7041 RIVERVIEW AVENUE

SHEET NO. A-5	MODEL ELDER	SET NO. ELD00
	DRAWING TITLE PLUMBING PLAN	VERSION 01 RELEASE NO. ---- DRAWN BY DATE: OPTION

DIV-COMM-LOT-UNIT DCY-S2-0405	
COMM-LOT SANTERS MILL - SIMPLY RYAN - 0405	
STREET ADDRESS TO41 RIVERVIEW AVENUE	APT. NO. ----
CITY MIDDLETOWN	STATE OH
	ZIP 45042

PLUMBING PLAN
SCALE: 1/4" = 1'-0"

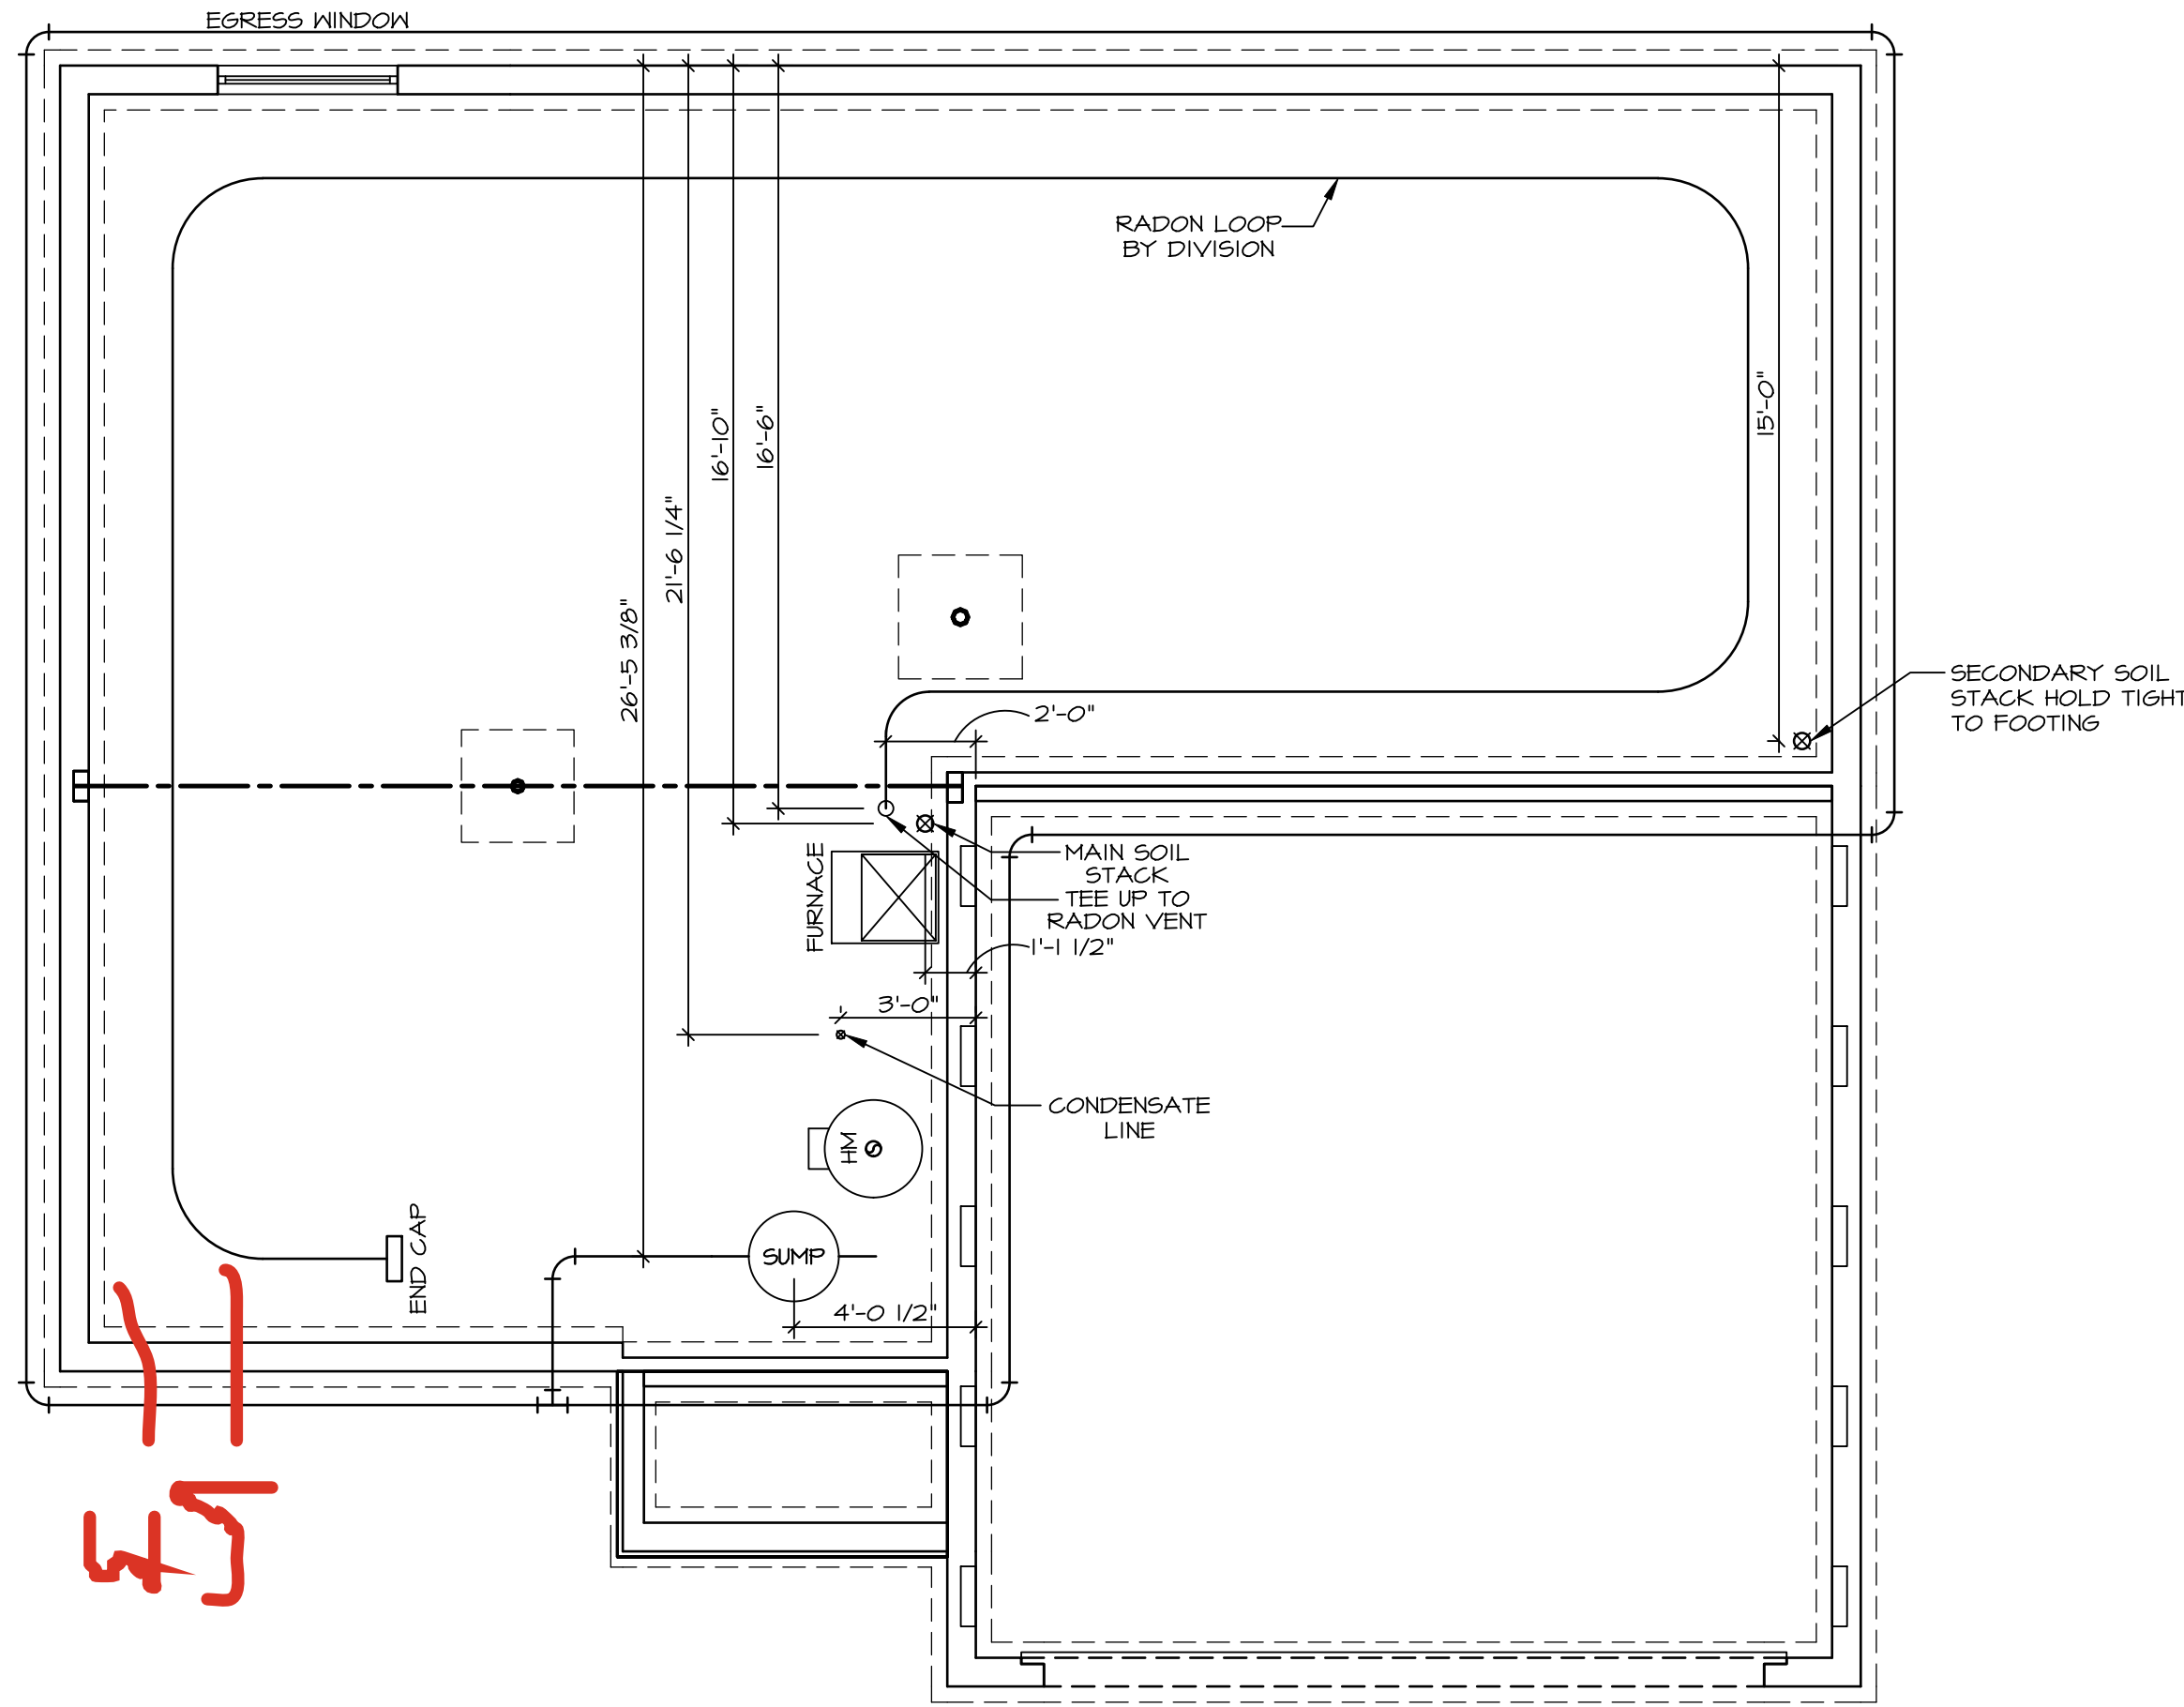
Need to bring sump pump and install it !!

2 hose bibs - no valves required

Vent Kitchen

ice maker

1 tub

1 shower

WATER HEATER ELECTRIC 50 GALLON

Inside Water Meter setup

Gas Furnace
